# Access Compliance Report

## Public Rights-of-Way

Intersection ID: 50866	Main Street: LAKEVIEW_RD	Cross Street: CUSHING_DR	Location: NW
ADA ID: 13DDC67E81BB	Ramp Type: Perp	Initial Pass/Fail: Fail	Overall Compliance: No
Codes/Mitigation Info/Possible Solution		Field Measurements/Component Compliance	
Severity Score: 21.25

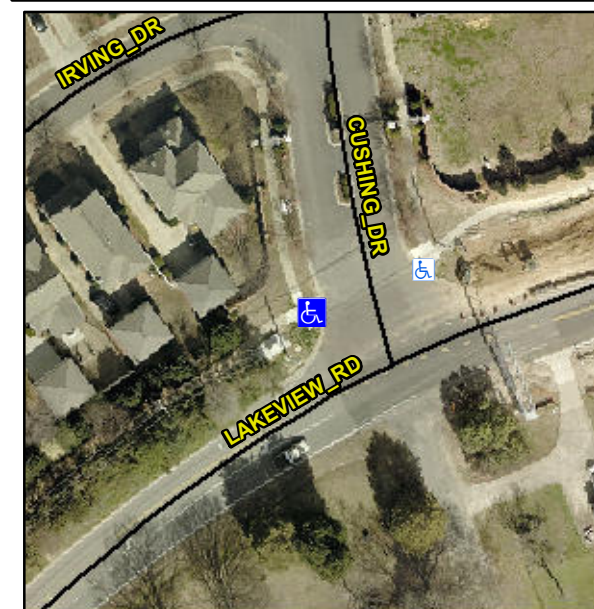
**Not Found, R304.5.1, R304.2.2**

Compliance	Description	Data	Compliance	Description	Data
N/A	Ramp Length (in)	95.0	No	Ramp Slope (%)	9.9
No	Ramp Width (in)	47.0	Yes	Ramp XSlope (%)	0.4
N/A	Flare Type LT	N/A	N/A	Flare Type RT	N/A
N/A	Flare Slope LT (%)	N/A	N/A	Flare Slope RT (%)	N/A
N/A	Flare Traversable LT?	N/A	N/A	Flare Traversable RT?	N/A
N/A	Landing Length (in)	N/A	N/A	DWS Provided?	N/A
N/A	Landing Width (in)	N/A	N/A	DWS Contrast?	N/A
N/A	Landing Slope (%)	N/A	N/A	DWS Length (in)	N/A
N/A	Landing X Slope (%)	N/A	N/A	DWS Full Width?	N/A
N/A	Landing Curb? (Y/N)	N/A	N/A	DWS Offset (in)	N/A
N/A	Shared Landing?	N/A			
N/A	Gutter Ponding?	N/A	N/A	Gutter Slope (%)	N/A
N/A	Gutter Lip Ht (in)	N/A	N/A	Gutter X Slope (%)	N/A
N/A	Painted X Walk1?	No	N/A	Painted X Walk2?	N/A
	X Walk 1 Direction	To E		X Walk 2 Direction	N/A
N/A	X Walk 1 Width (in)	N/A	N/A	X Walk 2 Width (in)	N/A
	X Walk 1 Slope (%)	1.7		X Walk 2 Slope (%)	N/A
	X Walk 1 X Slope (%)	0.0		X Walk 2 X Slope (%)	N/A

**Remove & Replace Entire Ramp.**
